04-OCT-2000

SUBJECT: ON Semiconductor Product Bulletin 10318

TITLE: SC74 PACKAGE STANDARDIZATION AND LEADFRAME CHANGE

Figure 1: SC74 Case Outline

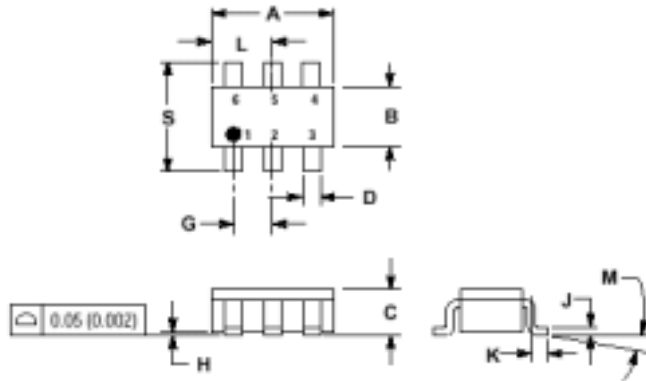
SC74 Package Dimension Standardization:
Package dimension standardization consists of changes in the package length (dim. A), package height (dim C.) and the lead width (dim. D). Please refer to Table A for dimensional changes.

The ON Semiconductor SC-74 package is comparable to many competitor packages. Rohm and Phillips Semiconductor SC74 package dimensions are compared to ON Semiconductor's SC-74 package on Table B. Please note Figure 1 for dimensional notation, i.e. Package length noted by 'A'.

DIM.	OLD DIMENSION		NEW DIMENSION		JEDEC STANDARD	
	Min:	Max:	Min:	Max:	Min:	Max:
A	0.1063"	0.1220"	0.1142"*	0.1220"*	0.1083"	0.1201"
C	0.0394"	0.0511"	0.0354"	0.0433"	NA *	0.0433"
D	0.0138"	0.0196"	0.0098"*	0.0197"	0.0118"	0.0197"
